**PHASE 4 DRAINAGE TECHNICAL NOTE
RESPONSE TO LLFA QUERIES
REFERENCE: DC/24/1158**

**Southwater,
Phase 4**

**Prepared for
St Edward Homes
Limited**

SMA Ref: S832-STU05-XX-XX-RP-C-075-005

PHASE 4
ATTENUATION POND SECTIONS

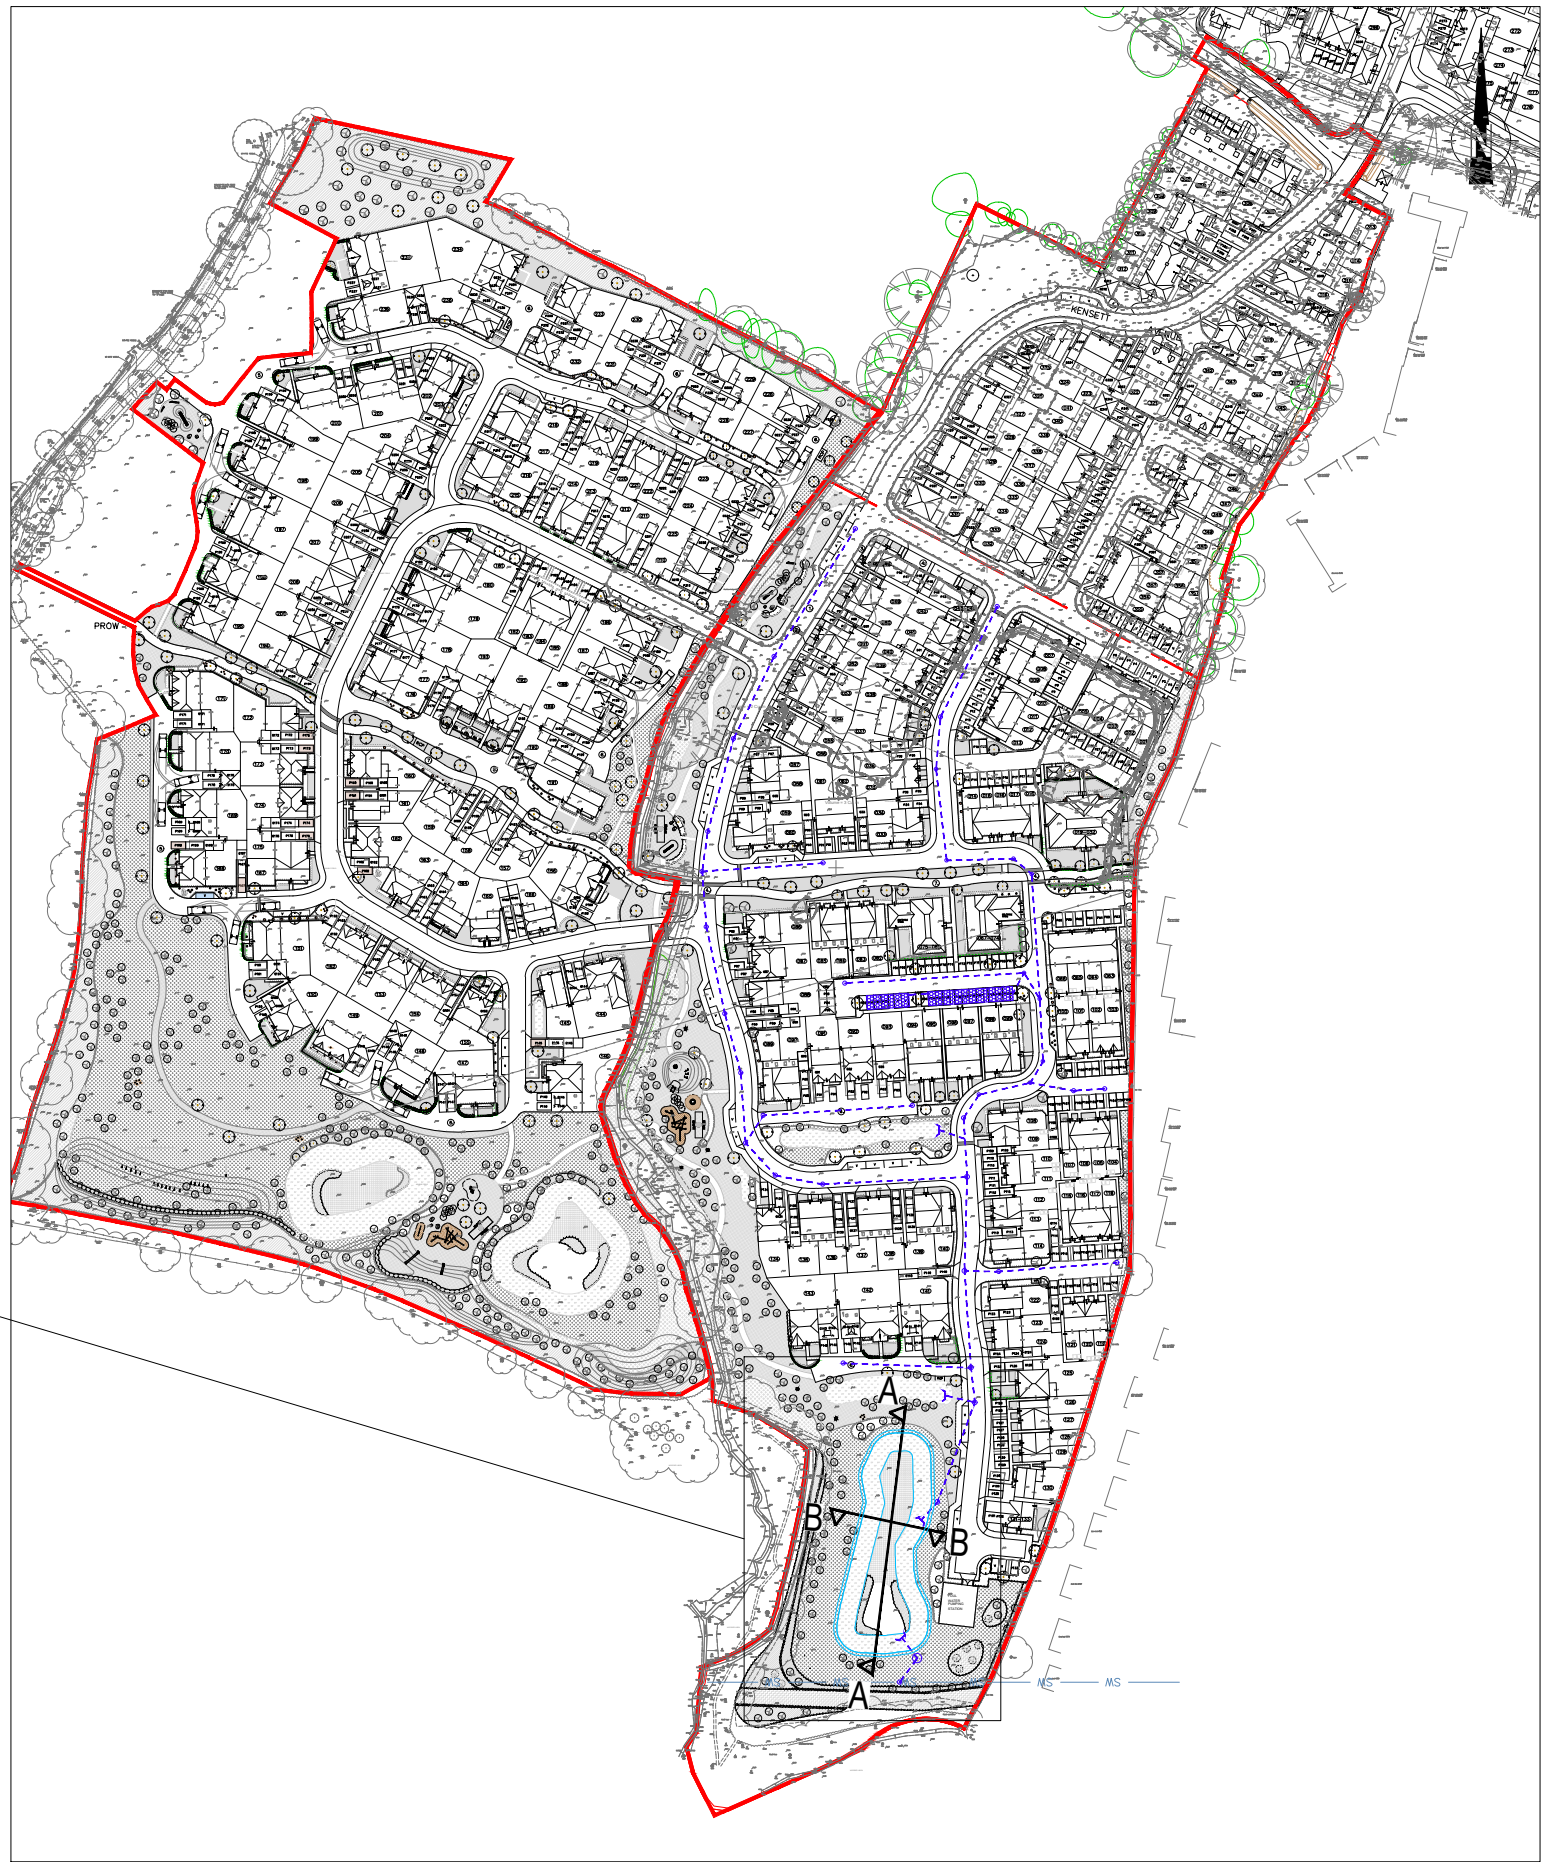
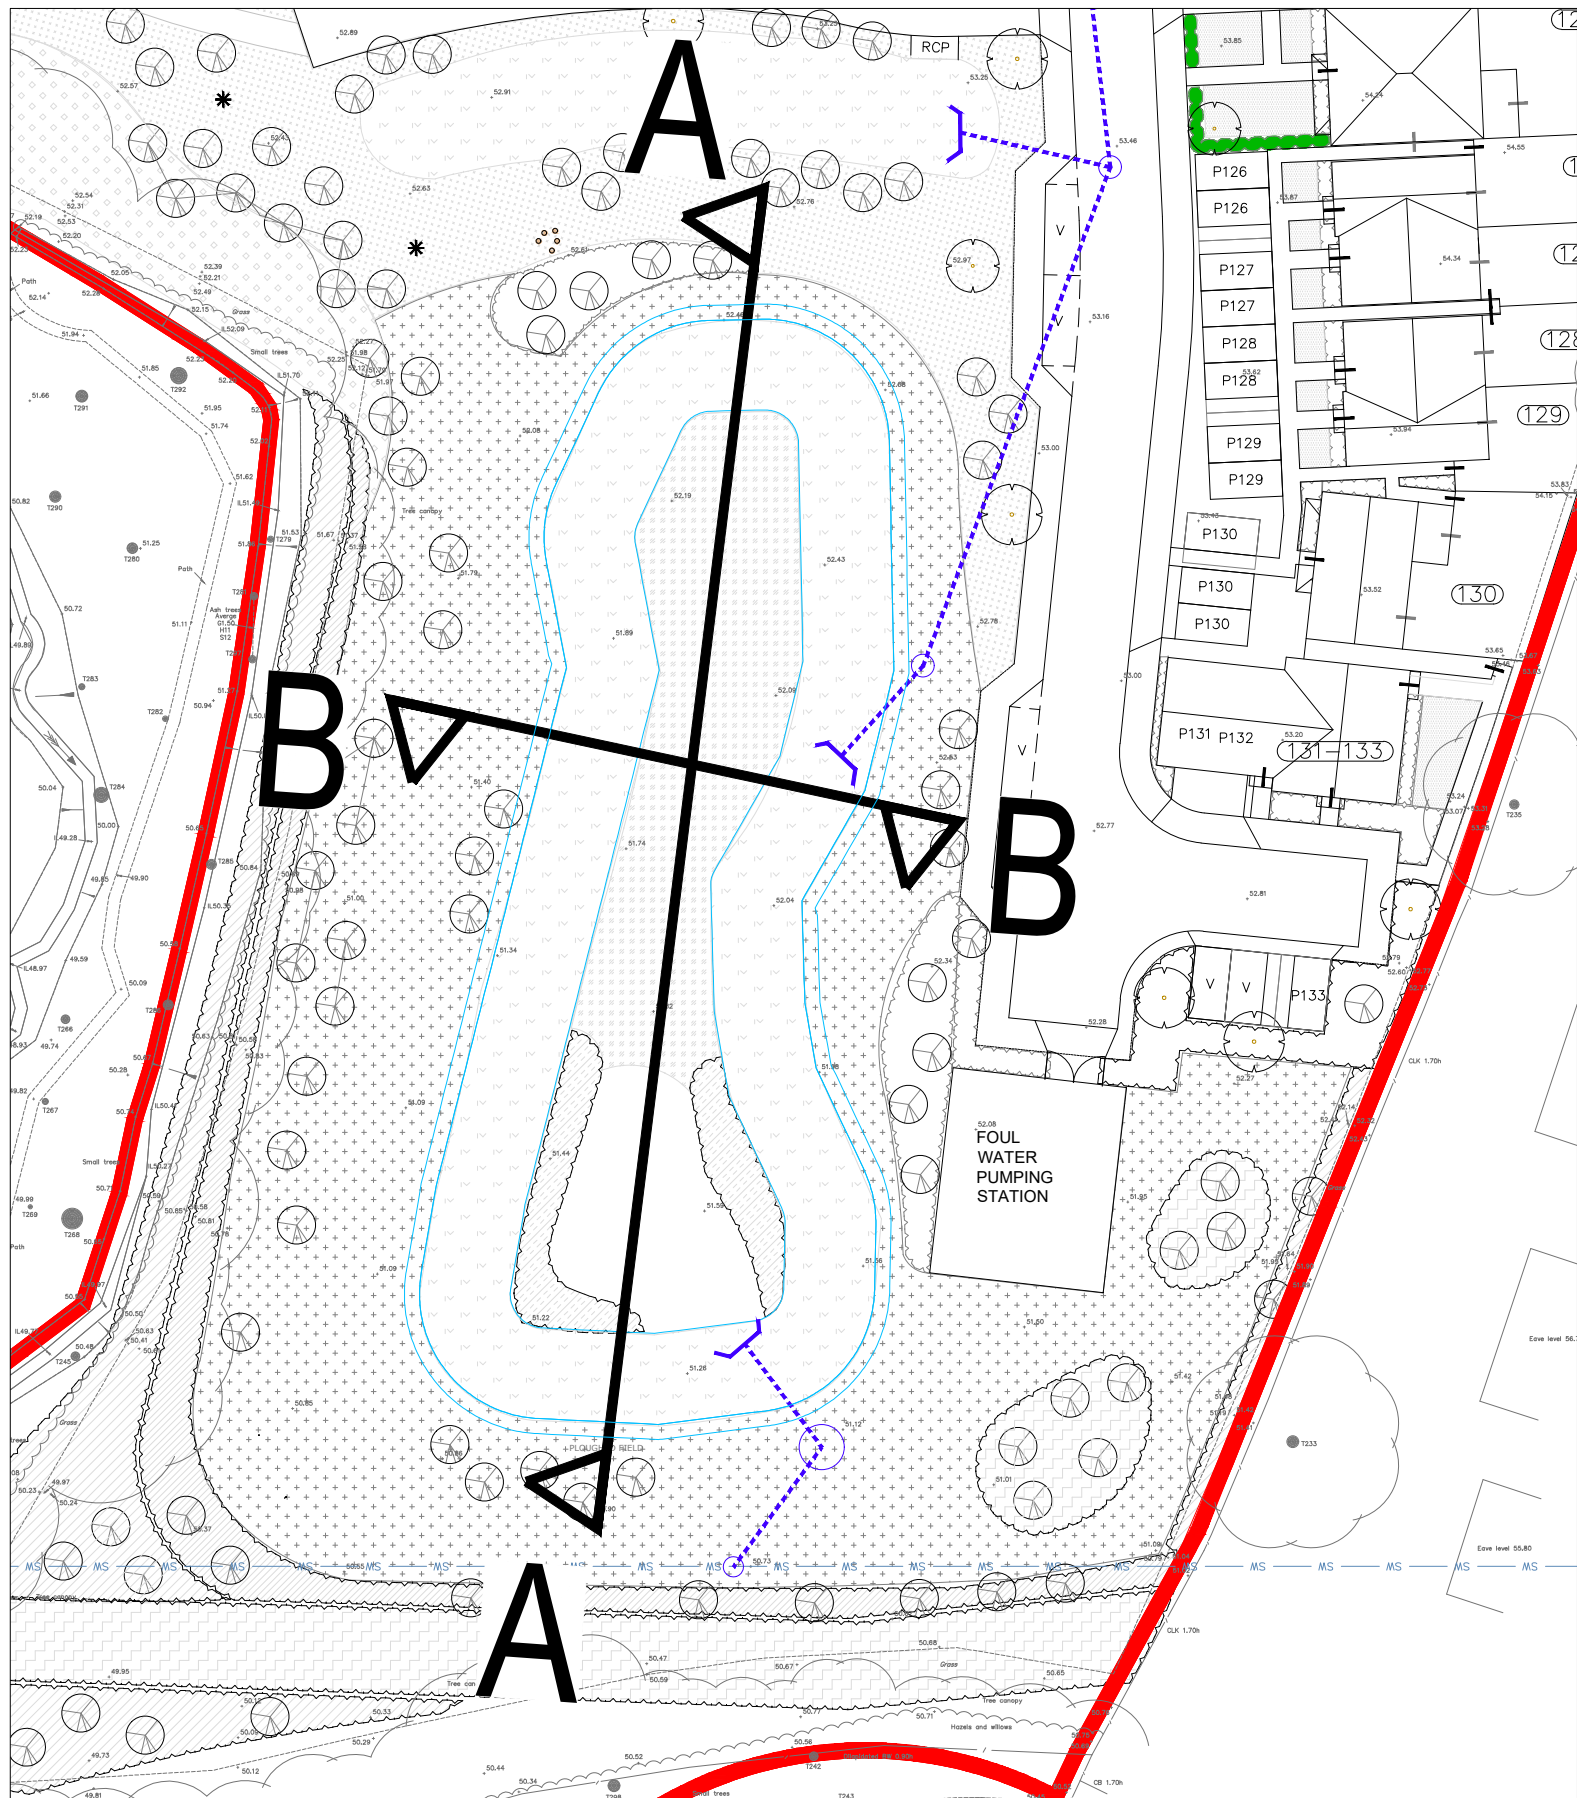
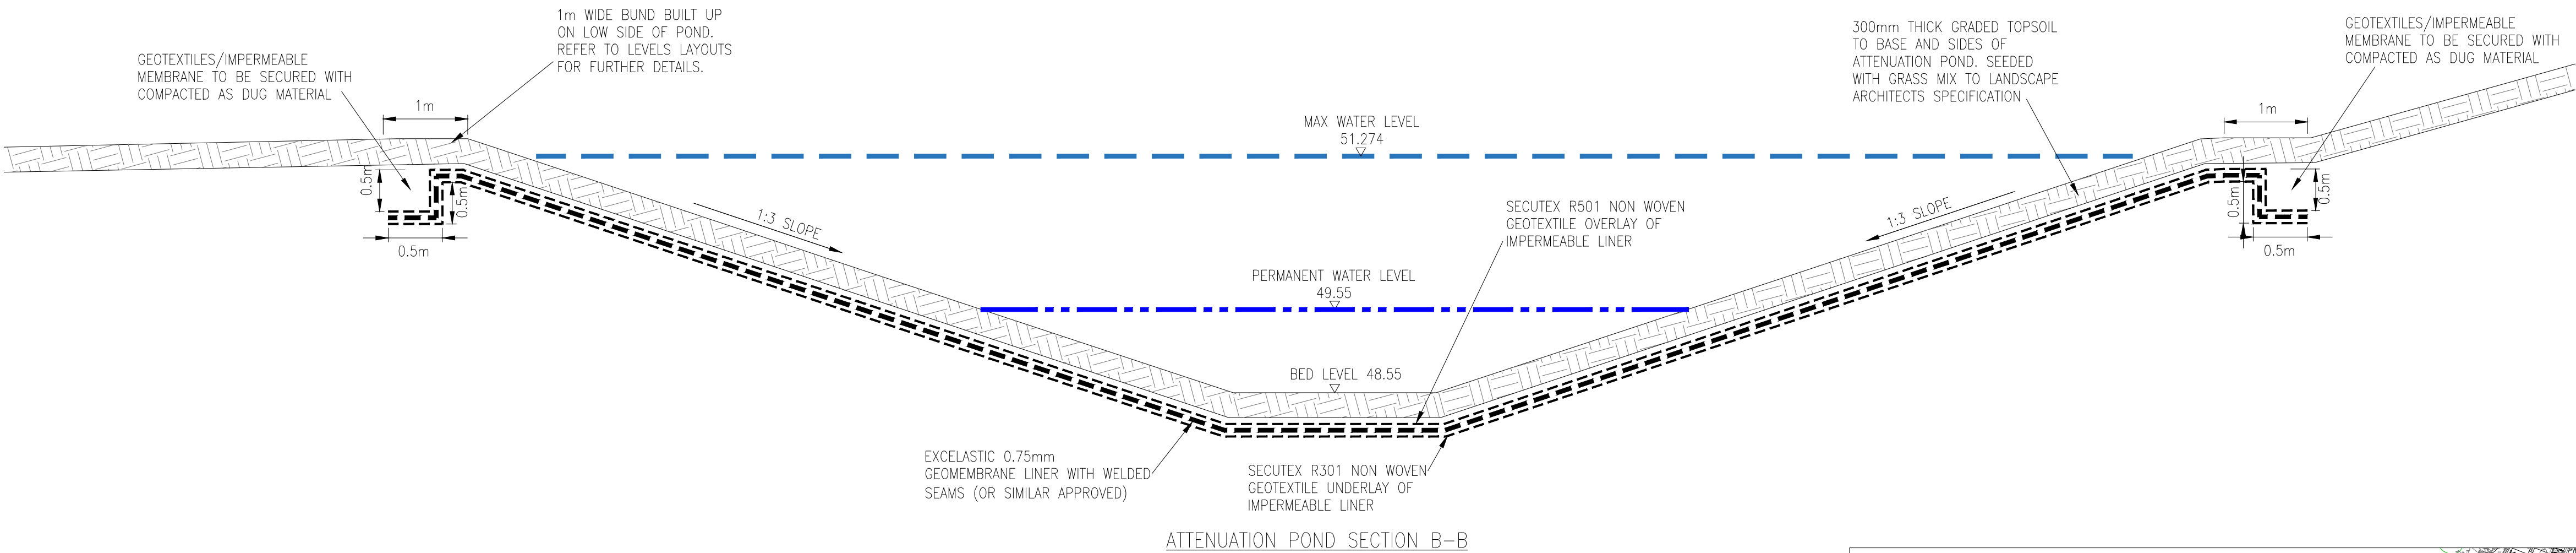
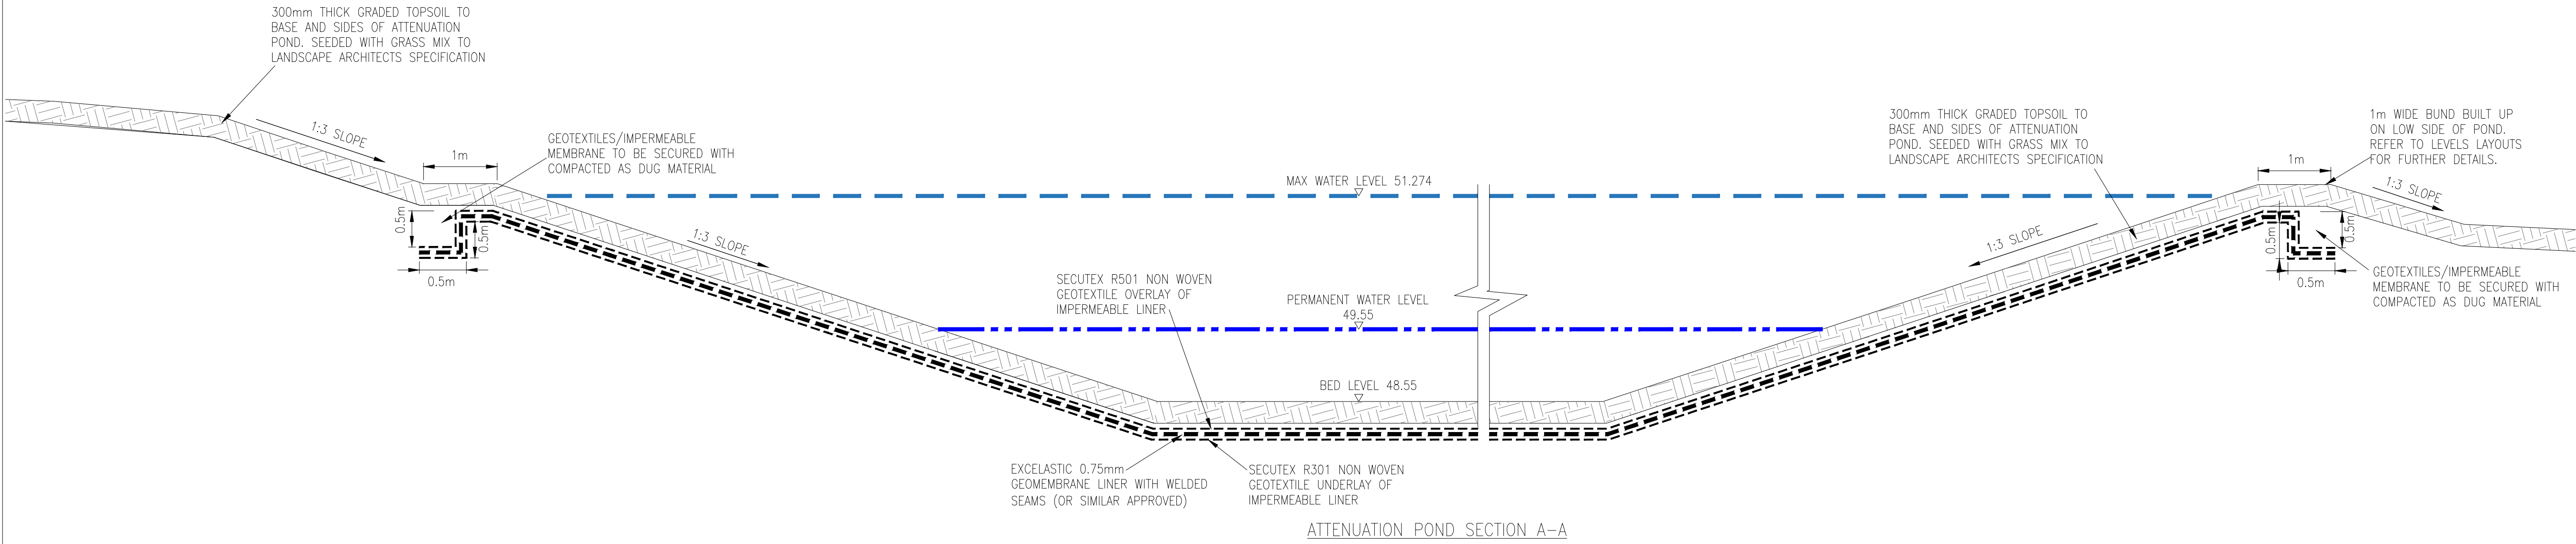
- 3.6 *For the basin, cross sections are required to ensure suitable side slopes and depths are being used. 2m is very deep for a basin, as an authority we suggest 1m for safety, amenity and biodiversity reasons but we appreciate this may be difficult to achieve for this site. Additionally, the basin is in a flow path which will reduce its' capacity in storm events. The cross sections must clearly show areas proposed to always be wet compared to areas proposed to be dry except for storm events.*

- 3.7 Considering requirements on sections 2.2 as well as 2.4, it would not be possible to reduce the size of the pond/basin in any way. From a design perspective, the pond is a key feature of the development, central to the open space strategy to the development, any reduction in scale would be viewed negatively in terms of landscaping and placemaking. However, a balanced view was taken by the design team in terms of upsizing the pond due to the requirements of 2.2 & 2.4 above, hence additional attenuation has been dealt with by way of surface water storage crates.

- 3.8 Cross-section have been provided in **Appendix 4** for review.
